**ZONING AMENDMENT,  
PLANNED UNIT DEVELOPMENT &  
SUBDIVISION STAFF REPORT**

**Date: November 17, 2011**

<b><u>NAME</u></b>	Mr. Rooter Plumbing
<b><u>SUBDIVISION NAME</u></b>	Mr. Rooter Subdivision
<b><u>LOCATION</u></b>	2409 Wolf Ridge Road (Southwest corner of Wolf Ridge Road and Feed Mill Road [private street]).
<b><u>CITY COUNCIL DISTRICT</u></b>	District 1
<b><u>PRESENT ZONING</u></b>	R-1, Single-Family Residential District
<b><u>PROPOSED ZONING</u></b>	B-3, Community Business District
<b><u>REASON FOR REZONING</u></b>	Changing conditions.
<b><u>AREA OF PROPERTY</u></b>	3.4 Acres ±
<b><u>CONTEMPLATED USE</u></b>	<p>Subdivision approval to create one legal lot of record from an existing metes-and-bounds parcel, Planned Unit Development Approval to allow multiple buildings on a single building site with shared access between multiple building sites, and Rezoning from R-1, Single-Family Residential District, to B-3, Community Business District, to allow a commercial plumbing business.</p> <p><b>It should be noted, however, that any use permitted in the proposed district would be allowed at this location if the zoning is changed. Furthermore, the Planning Commission may conside

# SITE PLAN

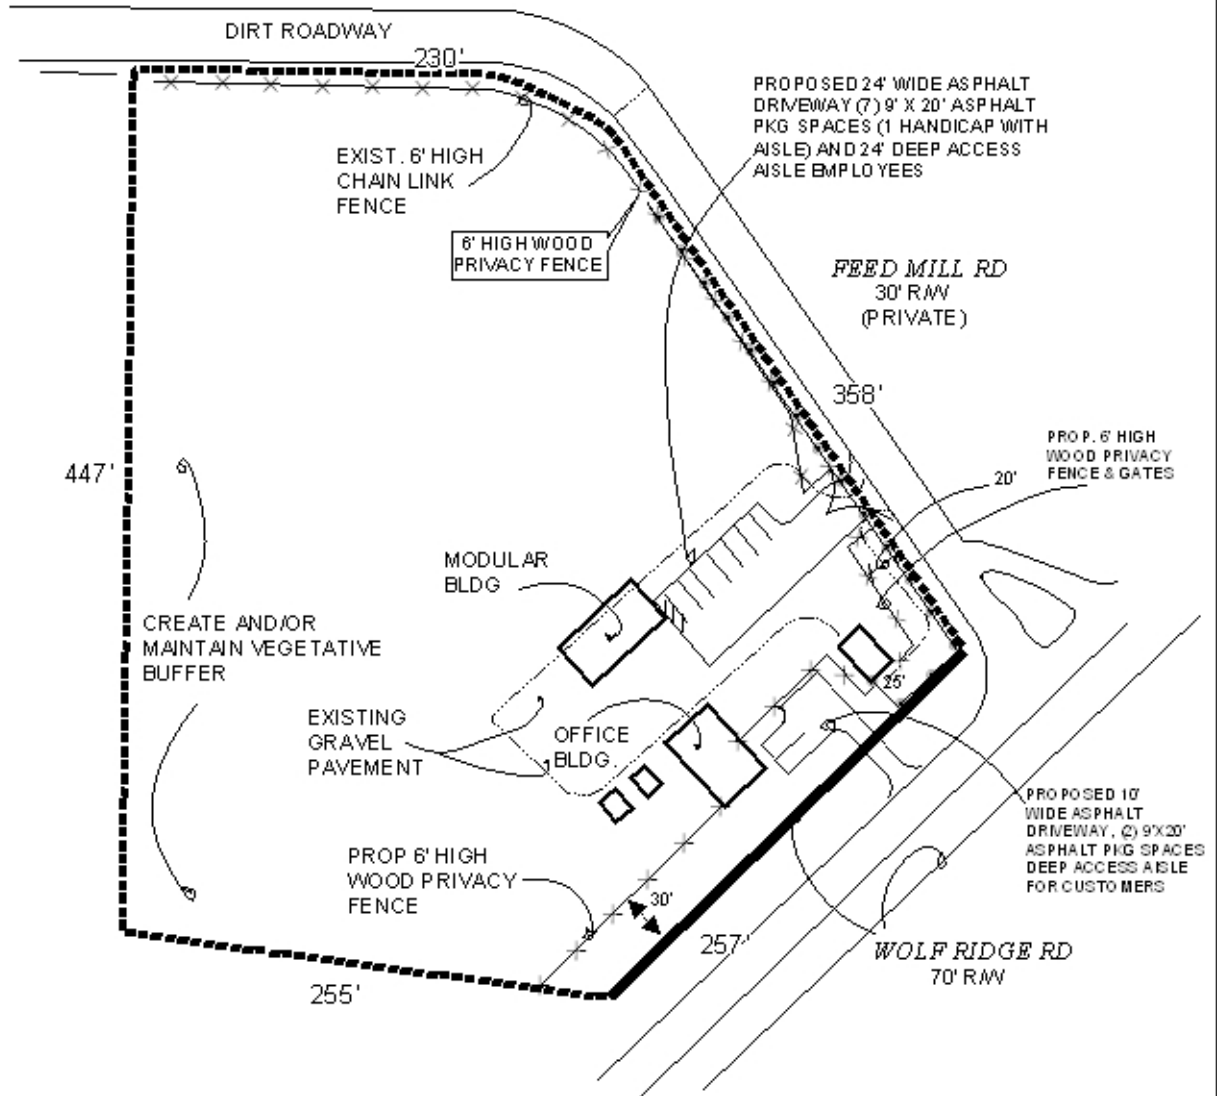
The site plan/preliminary plat submitted has many deficiencies which can be bundled into a common review of revisions required before an in-depth analysis for the viability of the individual applications can be attempted.

The proposed lot meets the minimum size requirements, as regulated by the Subdivision Regulations. However, Wolf Ridge is indicated to currently have a 70' right-of-way width. As this is a component of the Major Street Plan with a planned 100' right-of-way, dedication would be required to provide 50' from the centerline of Wolf Ridge Road, with the 25' minimum building setback measured from any required dedication. As this would impact structures placed near the front along Wolf Ridge Road without proper permits after the applicant's purchase, the plat should be revised to indicate the un-permitted structures relocated to a compliant location on the site. The proposed 6' high wood privacy fence should also be relocated to meet the required setback after dedication.

Access management is also a concern. The plat illustrates a substandard 10' wide driveway along Wolf Ridge Road leading to a 2-stall substandard parking area. The driveway should be revised to a compliant 24' width with a compliant parking area outside of the required dedication. Since the site shares access to other commercial and residential sites in the area via Feed Mill Road, a private street with a substandard 30' right-of-way, and the fact that the owner of the street does not wish to participate in the P.U.D., such access to Feed Mill Road cannot be considered. Therefore, the site plan should be revised to eliminate all access to Feed Mill Road. The parking area associated with the Feed Mill Road entrance should be incorporated into any parking area associated with a revised Wolf Ridge Road access. The gravel pavement should be revised to compliant paving as gravel surfaces are not allowed in B-3 districts.

The site plan does not indicate a dumpster, a sidewalk along Wolf Ridge Road, landscaping calculations, tree planting, or parking calculations. For the Planned Unit Development and Rezoning, the site plan should be revised to include such.

- 1) revision of the site plan to provide dedication of 50' from the centerline of Wolf Ridge Road;

- 2) revision of the site plan to illustrate the 25' minimum building setback line along Wolf Ridge Road as measured from any required dedication;
- 3) revision of the site plan to relocate un-permitted structures to a compliant location on the site meeting the revised 25' minimum building setback;

- 4) revision of the site plan to relocate the 6' wood privacy fence along Wolf Ridge Road to a compliant location on the site meeting the revised 25' minimum building setback;

- 5) revision of the 10' driveway along Wolf Ridge Road to a compliant 24' width;
- 6) revision of the front parking area to be out of any required dedication;

- 7) revision of the site plan to eliminate any access to Feed Mill Road;
- 8) revision of the site plan to incorporate the parking area off Feed Mill Road into any parking area associated with a revised Wolf Ridge Road access;

- 9) revision of the site plan to indicate compliant paved parking in the area indicated as gravel parking;
- 10) revision of the site plan to include a compliant dumpster, or the placement of a note on the site plan stating that refuse service will be either private or curbside;

- 11) revision of the site plan to indicate a compliant City-standard sidewalk along Wolf Ridge Road;
- 12) revision of the site plan to include landscaping area calculations; and

- 13) revision of the site plan to include required parking calculations.
